RE: Southeast Landfill Financial Responsibility Cost Estimates
Permit No.: SO29-158504, Hillsborough County

- 1. FDEP Statement 1 - The Department has no objections to the proposed Phase IV piezometer as shown in Figure 6. Please provide all record drawings and initial measurements of leachate depth over the clay liner as part of this permit application. This information is necessary to verify compliance with the engineer's design for leachate management.**

Figure 3. Slug Test Results, Phase IV Piezometer.

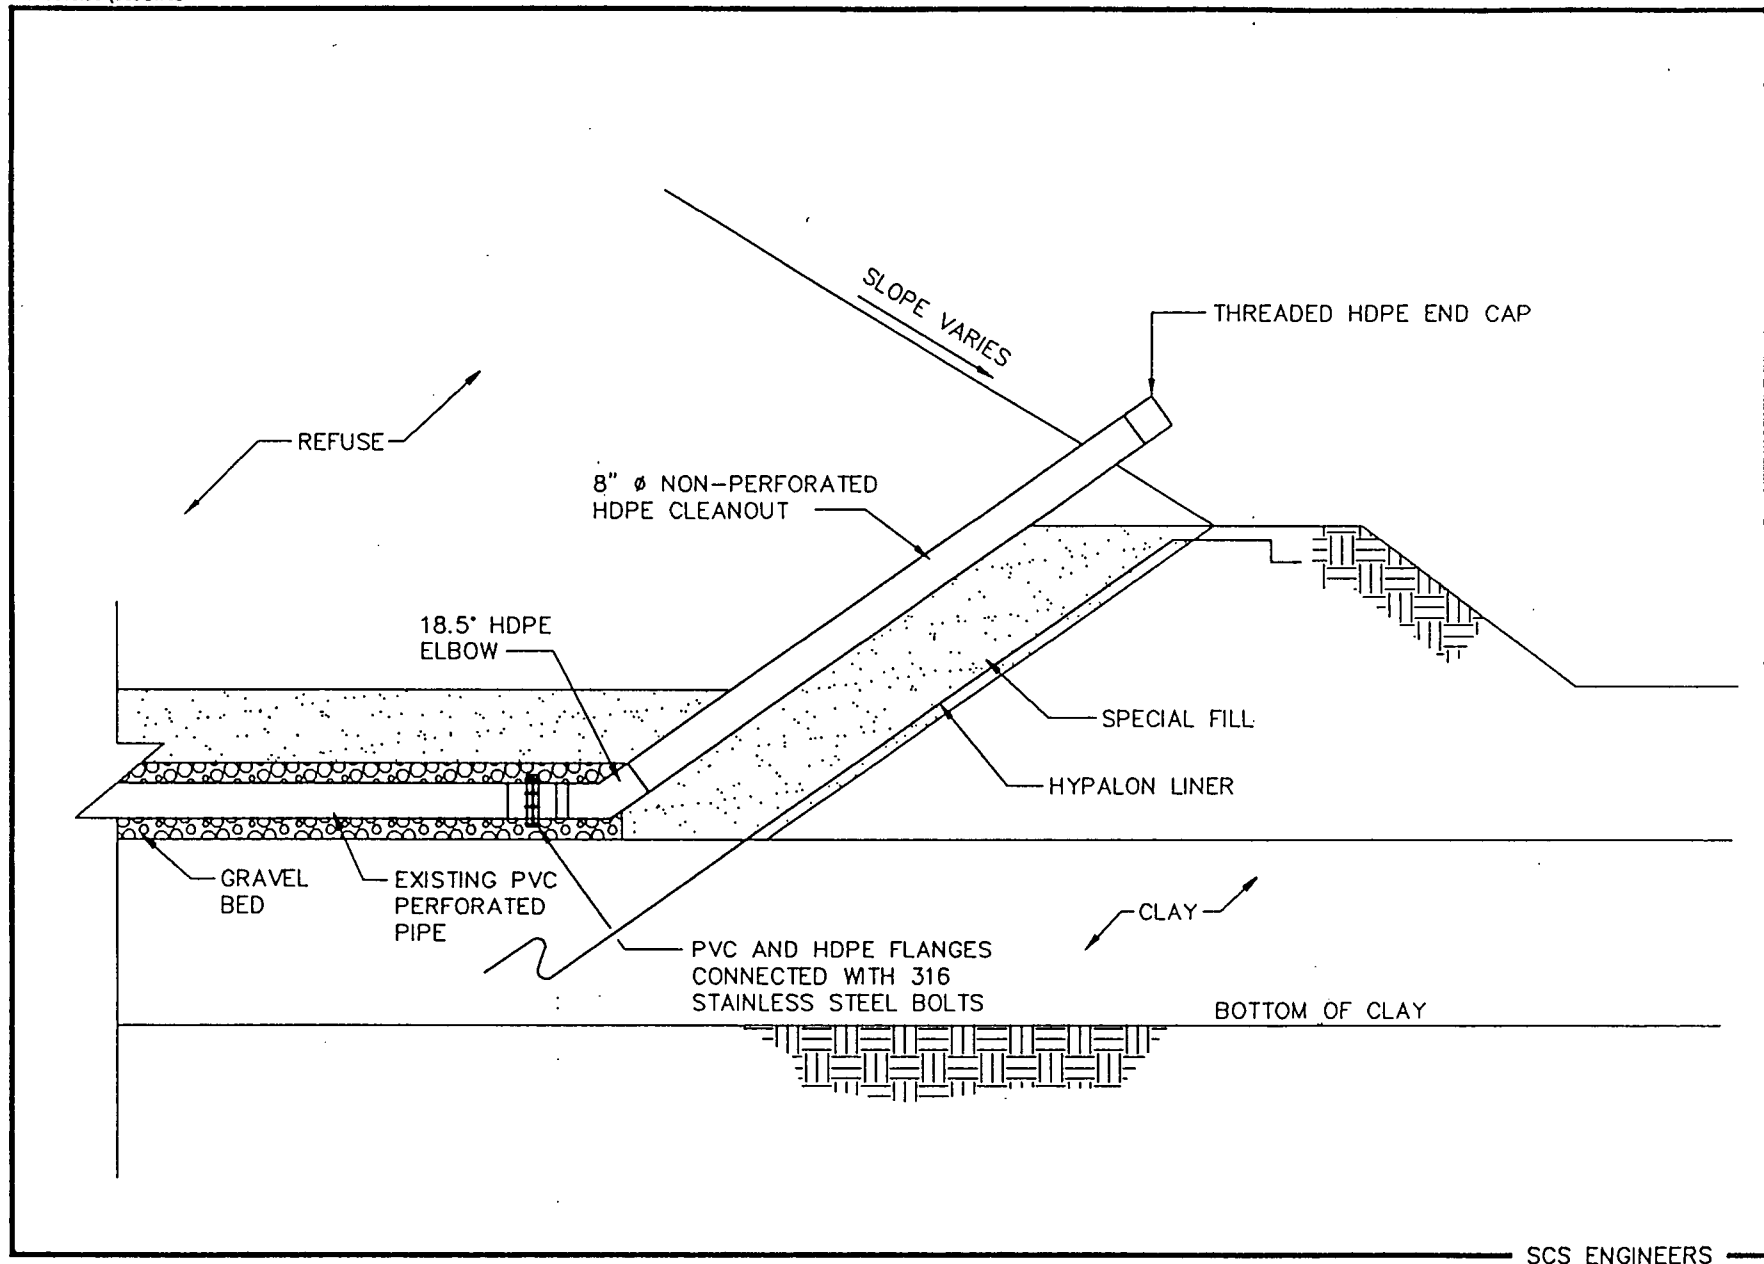
The cleanout detail is shown in Figure 2. In preparation for laying the cleanout, the track excavator excavated from the existing LCRS perforated PVC pipe toward the landfill perimeter on an approximate 3H:1V grade. In creating this trench, leachate began to flow from the gravel pack that surrounds the perimeter of the landfill into the excavation created for the cleanout. By the time backfilling was to begin (4:55 p.m.), the leachate level appeared to stabilize at 3 inches above the top of the pipe.
